REMARKS

This Application has been carefully reviewed in light of the Office Action mailed October 23, 2003. Applicants amend Claims 1 and 8 to correct typographical errors. Applicants also amend Claims 6, 12, 15, and 18 to clarify the original intent of these claims. Applicants respectfully request reconsideration and favorable action in this case.

FIG. 3

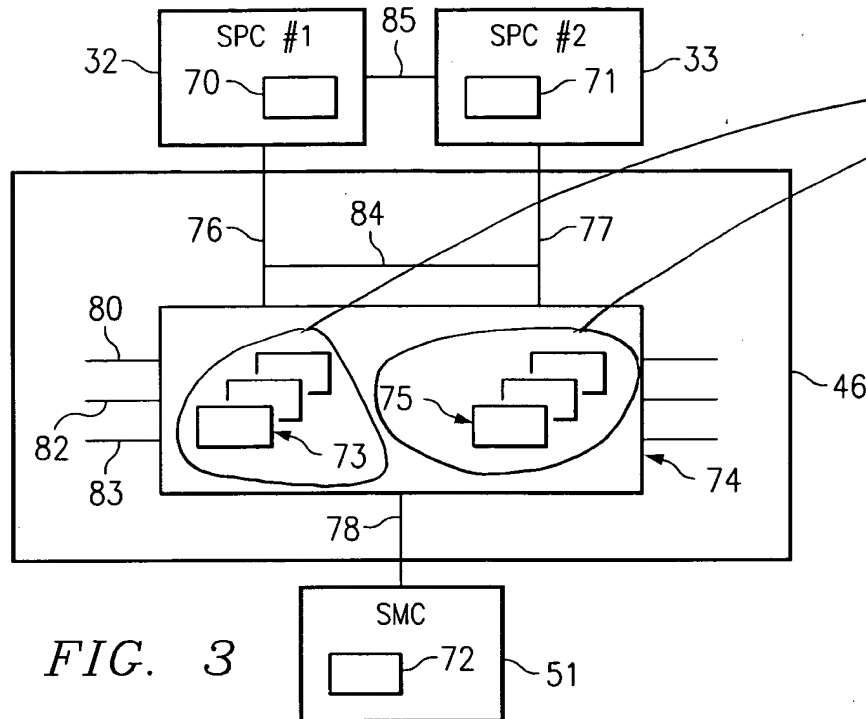
The Examiner objected to the drawings under 37 C.F.R. § 1.83(a) as not showing every feature of the invention specified in Claim 8. Applicants amend Figure 3 to include previously omitted diodes 73 and resistors 75. Applicants submit that these changes are fully supported by the specification as originally filed and therefore do not constitute new matter. For these reasons and other reasons clearly apparent, Applicants respectfully request reconsideration and withdrawal of the objection to the drawings.

Applicants amend the specification to include reference numerals 73 and 75. Applicants submit that these changes do not constitute new matter.
